CITY OF ALBUQUERQUE

Re: 7-Brews Coffee
3835 Coors Blvd. NW
30-Day Temporary Certificate of Occupancy
Transportation Development Final Inspection
Architect's Stamp dated 02-12-24 (G11-D067C)
Certification dated 07-07-2025

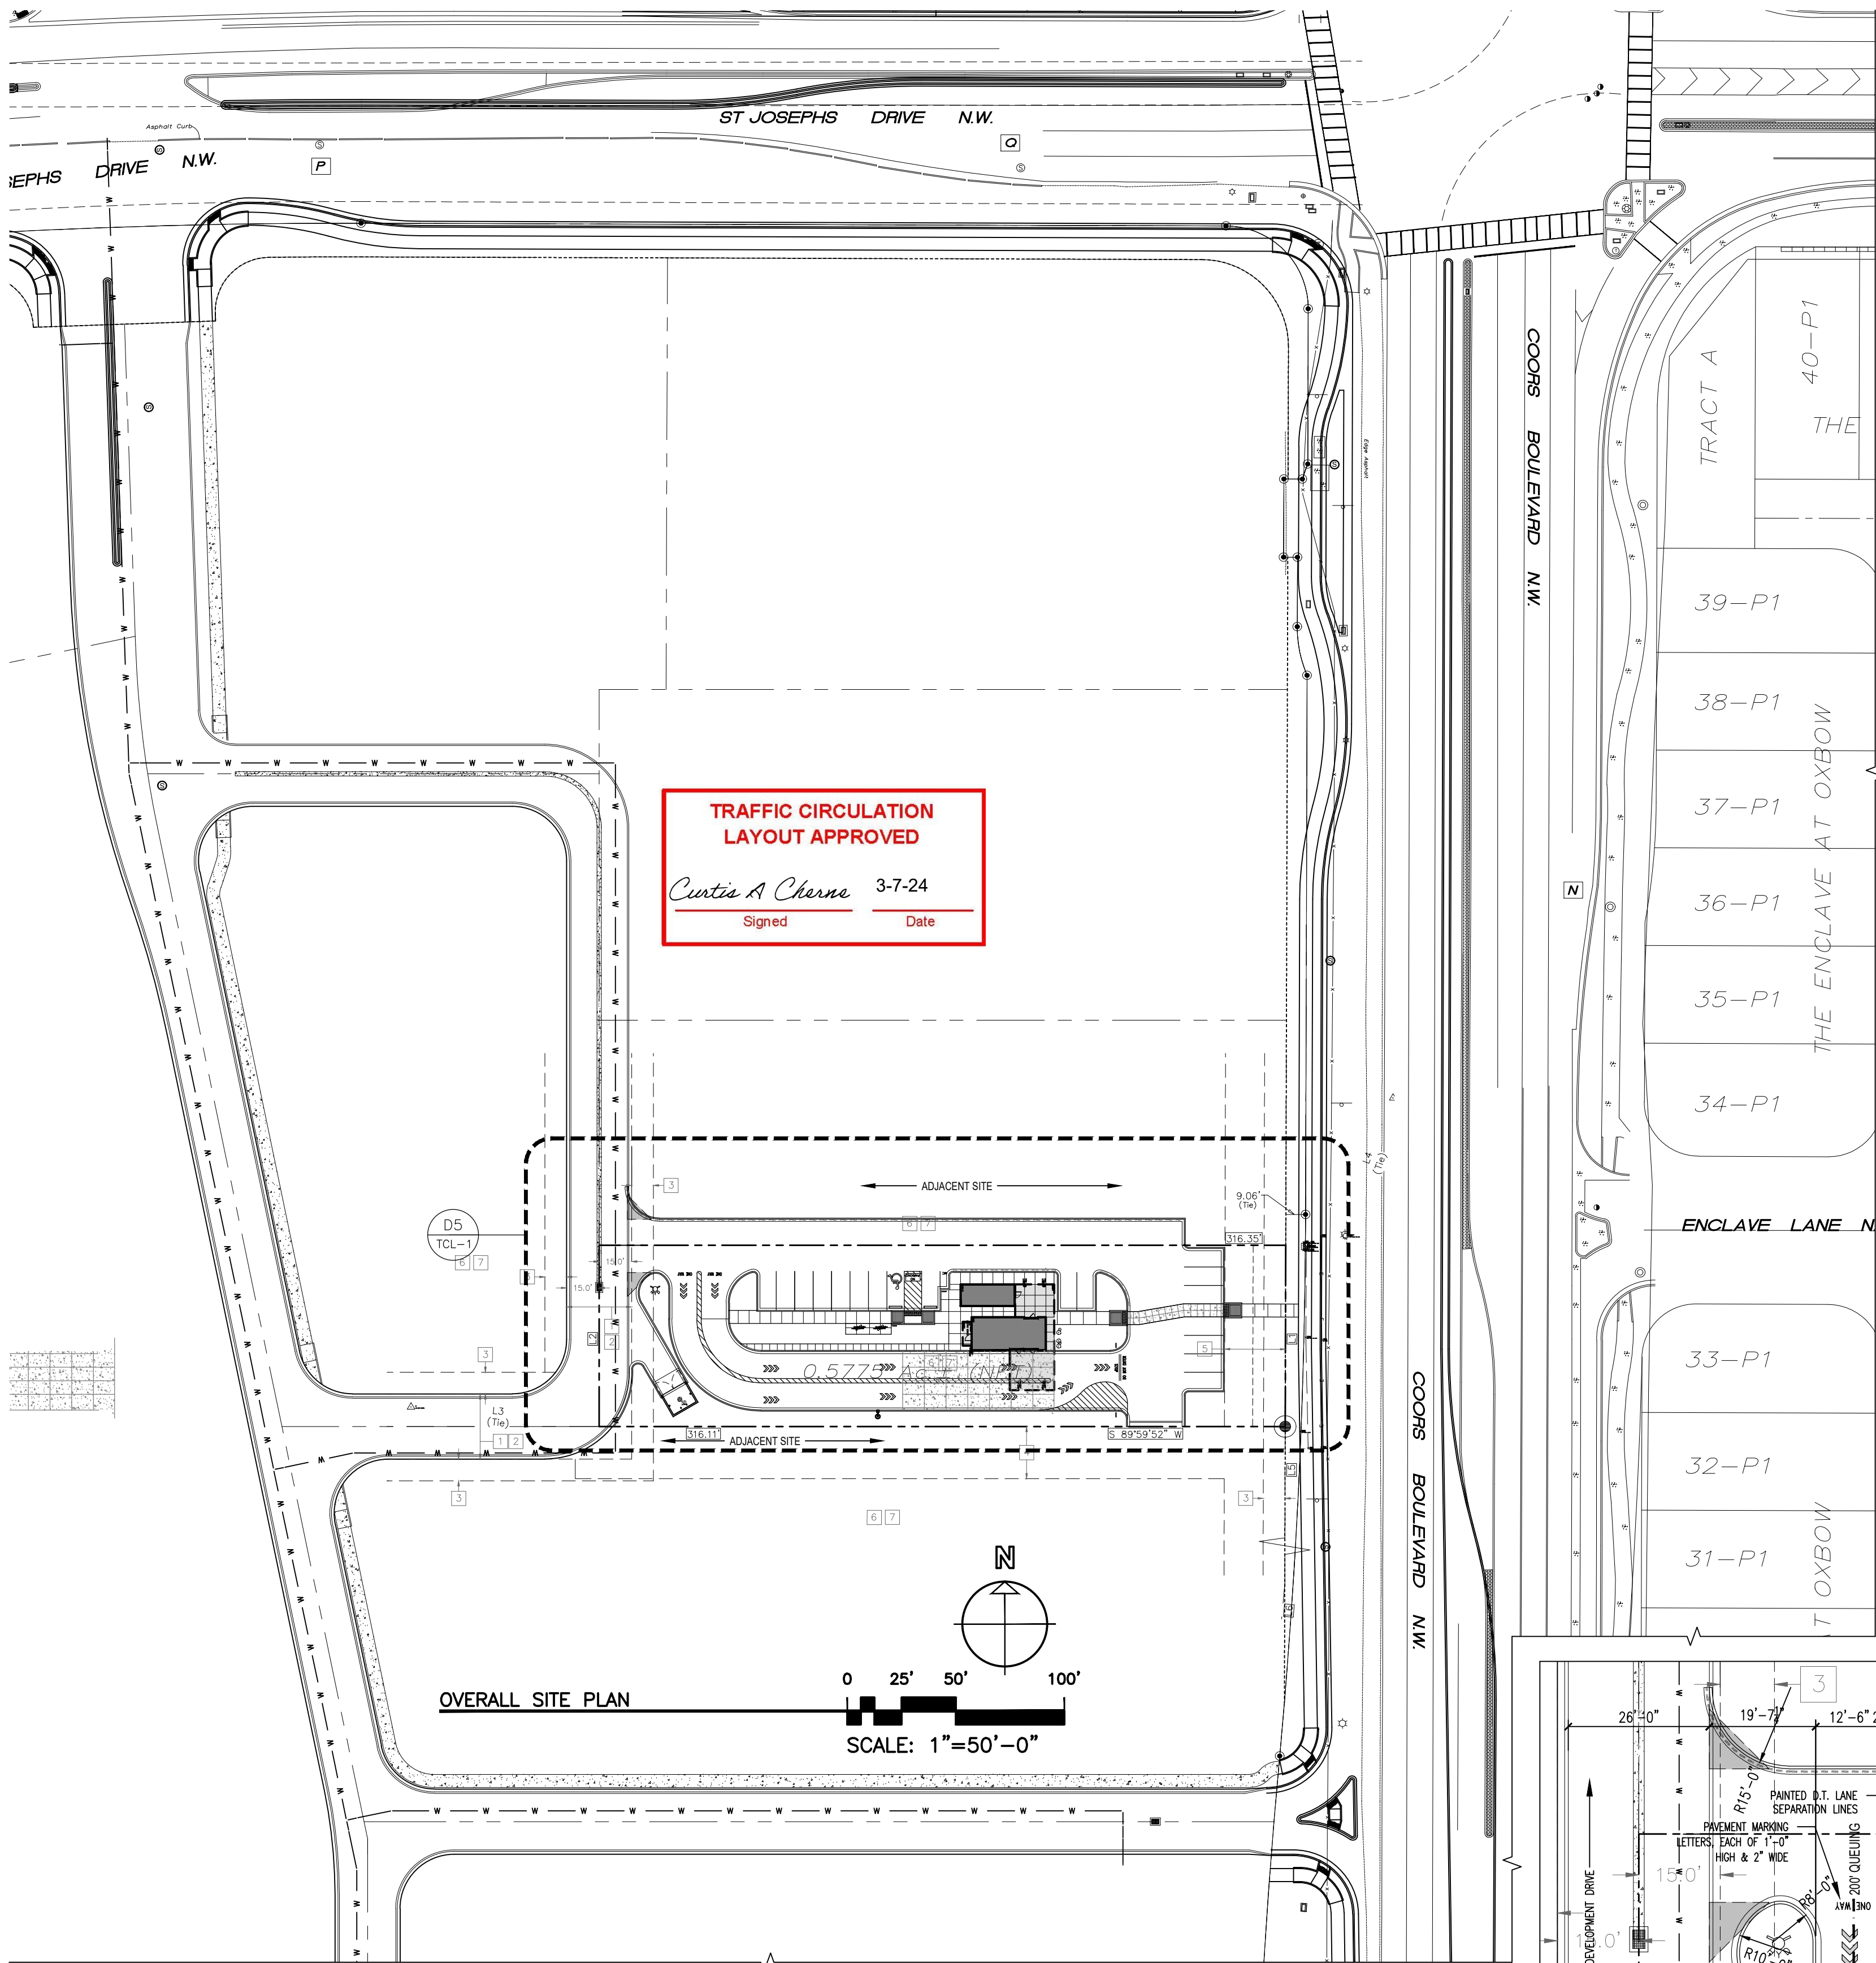
1. Please complete the construction of the accessible pathway.

C4 TYPICAL ADA PARKING STALLS DETAIL
1/4"=1'-0"

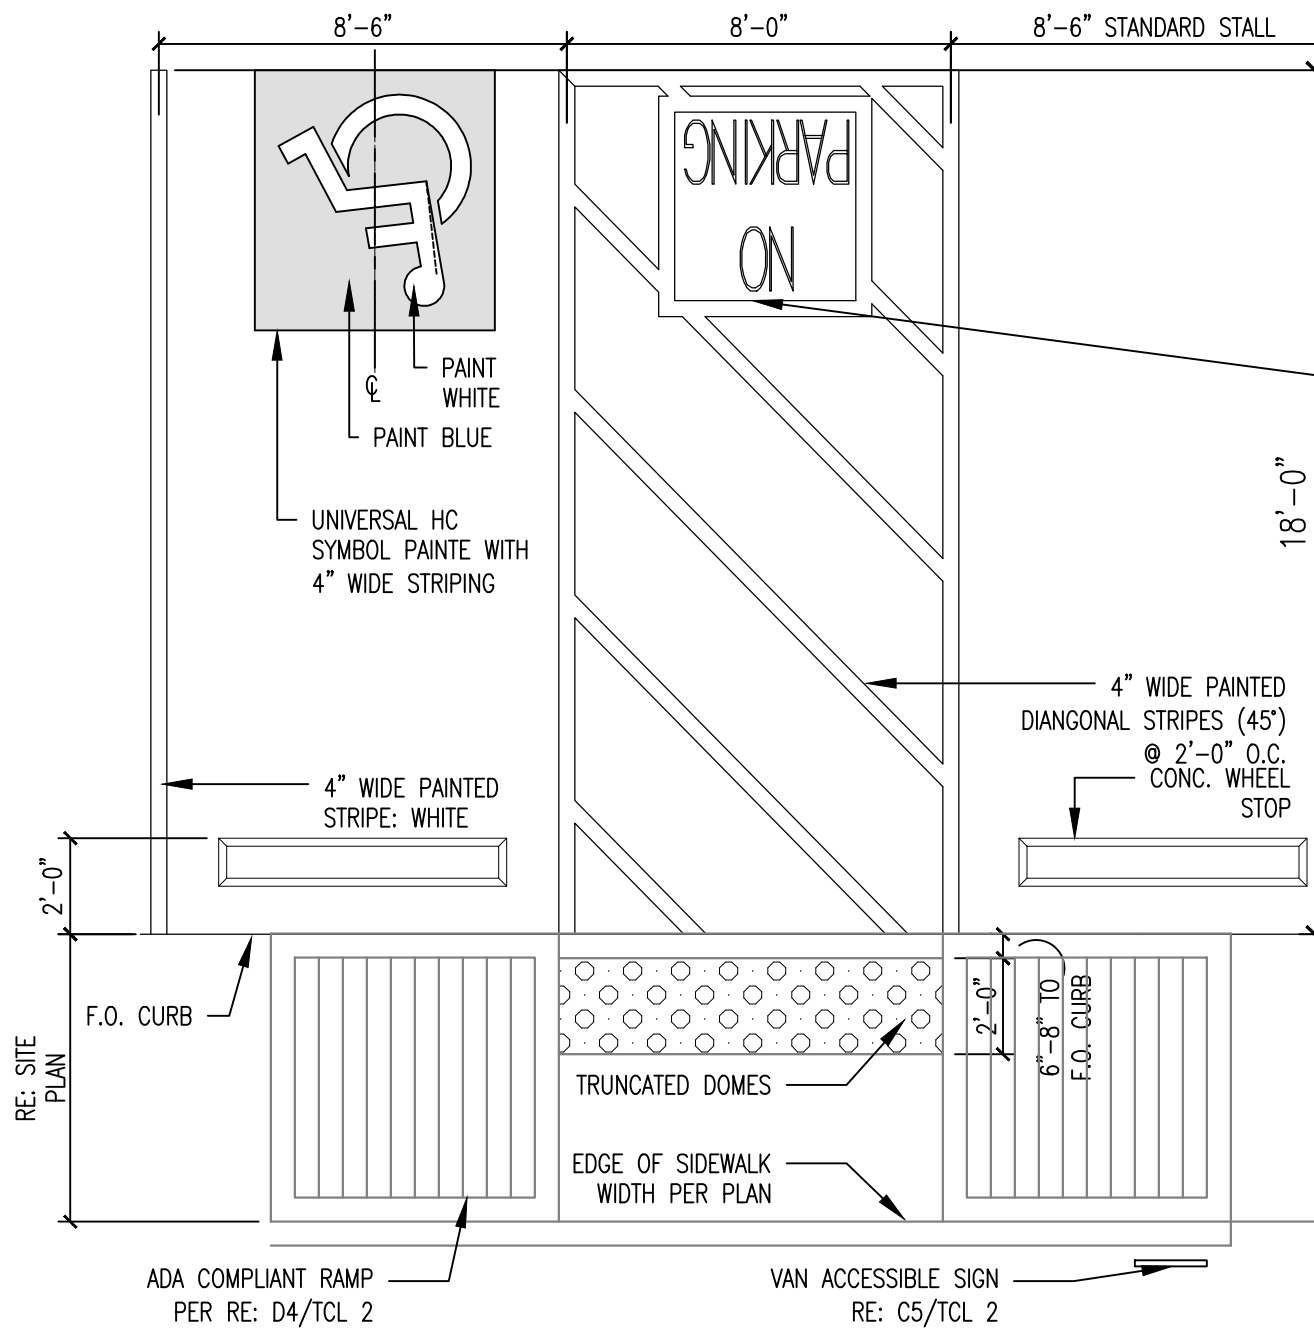
2. Per city requirements and the approved site plan the ADA parking space should be 8.6 ft wide. However, per the site visit the measured width was only 8 ft. Please revise to meet the minimum required width of 8.5 ft per city regulations.
